Office Action Summary	Application No. 10/527,967	Applicant(s) AMBROSI, JOHANN	
	Examiner JAY R. RIPLEY	Art Unit 3679

Claims 6-8 are rejected under 35 U.S.C. 102(b) as being anticipated by Horimoto (U.S. 5,857,713).

FIG. 10

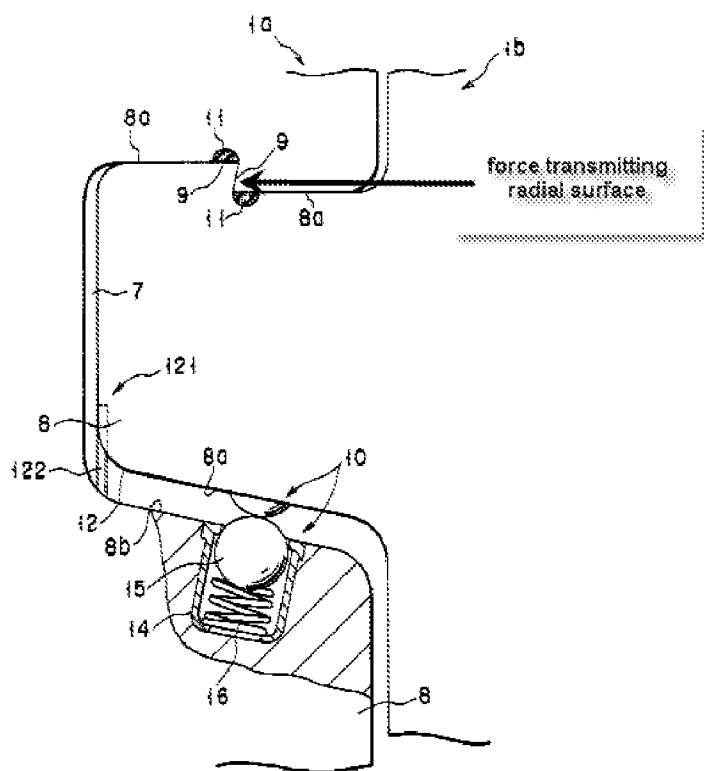
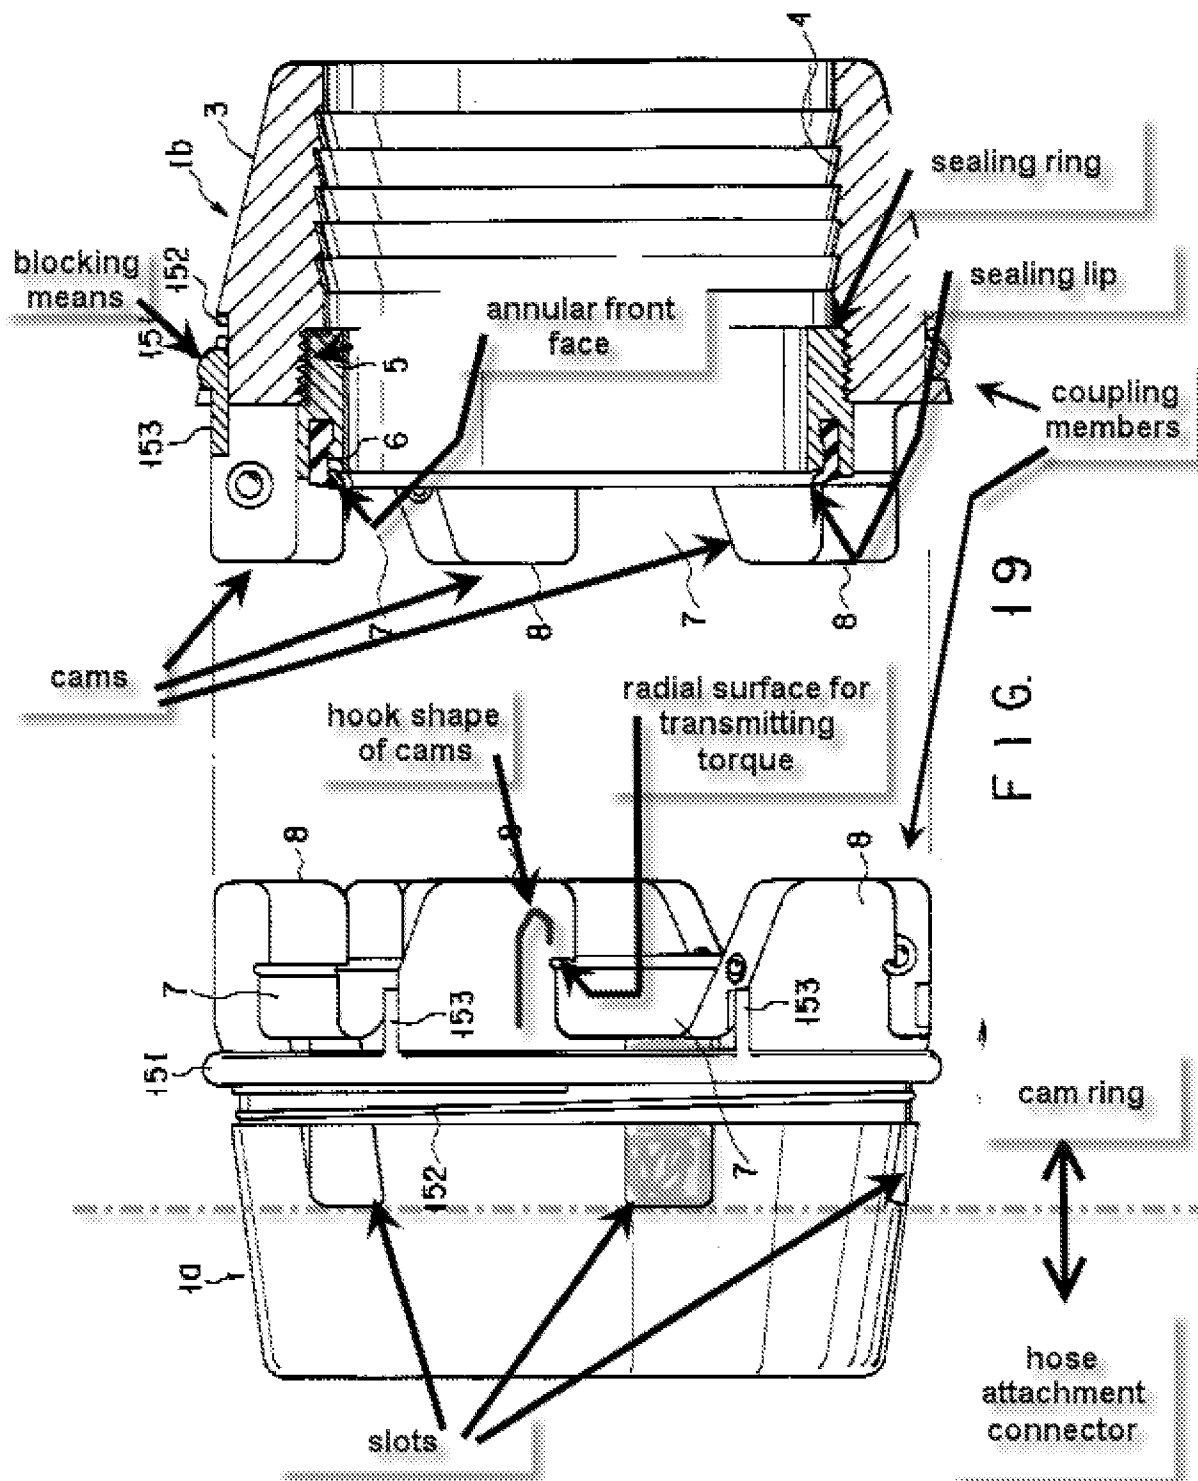
In regard to claim 1, Horimoto discloses in Figure 10 and Figure 19, the figures shown below, a symmetrical hose coupling comprising

In regard to claim 7, Horimoto further discloses that the radial surface areas of the cams are inclined in relation to the tangential direction (column 8, lines 26-30, and observed in Figure 10, above).

(Horimoto Figure 19)

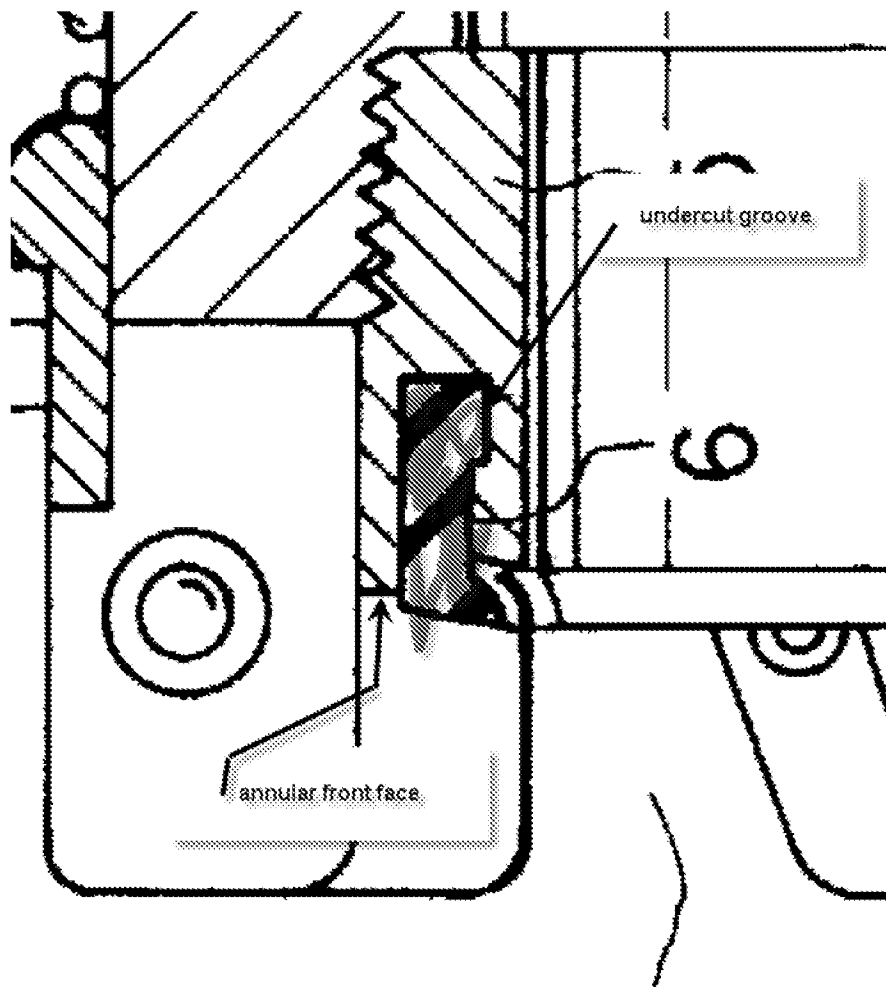
a pair of like coupling members (1a and 1b, as observed in Figure 19, below),

each of the coupling members having a cylindrical hose attachment connector (4) and a cam ring integrally formed with the cylindrical hose attachment connector (as observed in Figure 19, below), the connector having an outside diameter (the connector of Horimoto has numerous "outside" diameters, and as such, the Examiner arbitrarily chooses the "outside diameter" directly adjoining the "slots" noted in Horimoto Figure 19, shown below),

the cam ring having a plurality of integral cams (8) arranged on the periphery of the cam ring and projecting from the cam ring (the slots noted in Figure 19, below and in Attachment A, result in the cams projecting radially from the cam ring - the blocking means appears to be positioned by the slots - note that the slots "bottom", radially inner surface, is the outer radial surface of the cam ring), the cams projecting radially beyond the outside diameter of the cylindrical hose attachment connector for defining the largest outside diameter of the coupling (the Examiner notes that the "blocking means" shown in Figure 19, below, is a part added onto the coupling of Horimoto and, as such, is not a required part of the coupling nor is the "blocking means" a requirement of the instant claim), the cams being hook-shaped in a tangential direction of the cam ring and each having a radial surface area (9 in Figure 10) for transmitting an axial force, and the cams of the coupling members engaging into each other during coupling such that the radial surface areas engage behind each other (the coupling members engage each other in the recited fashion as indicated in column 13, lines 19-34).

In regard to claim 8, Horimoto further discloses, in Figure 19, above, and close-up of Figure 19, below, that the cam ring has an annular front face radially inwardly of the cams and an annular undercut groove is recessed in the annular front face for receiving a shaped sealing ring having a sealing lip which protrudes axially beyond the front face of the cam ring.

In regard to claim 10, Hiromoto discloses the claimed invention in the embodiment as shown in Figure 19, above, with the exception of a blocking means that does not project radially beyond the cams. The Examiner notes that Hiromoto does disclose that a blocking means (lock claws 153 as observed in Figure 19, above, and as disclosed in column 13, lines 19-34) is provided for locking the pair of coupling members with each other in a coupled condition; however, the disclosed blocking means of the embodiment shown in Figure 19 projects radially beyond the cams. Hiromoto teaches an alternative blocking means in Hiromoto Figures 9-14 (taught starting in column 9, paragraph 2, though column 12, first paragraph) which does not project radially beyond the cams. It would have been obvious to one having ordinary skill in the art at the time the invention was made to simply exchange the blocking means as disclosed by Horimoto in the embodiment shown in Figure 19 with the blocking means as taught by Hiromoto in relation to Figures 9-14 since they are functional equivalents.

Second, the Applicant is already aware that the "slots" shown in Figure 19, see above for visual clarification, are considered surfaces above which the cams extend. The Examiner noted this interpretation of the prior art of Horimoto in page 8, paragraph 4, of the Office action mailed 01/18/2008, and, further, it appears that the Applicant has simply chosen to dismiss such an interpretation of the prior art of Horimoto as indicated by the following statement from page 4, lines 14-16, of the reply filed 05/19/2008:
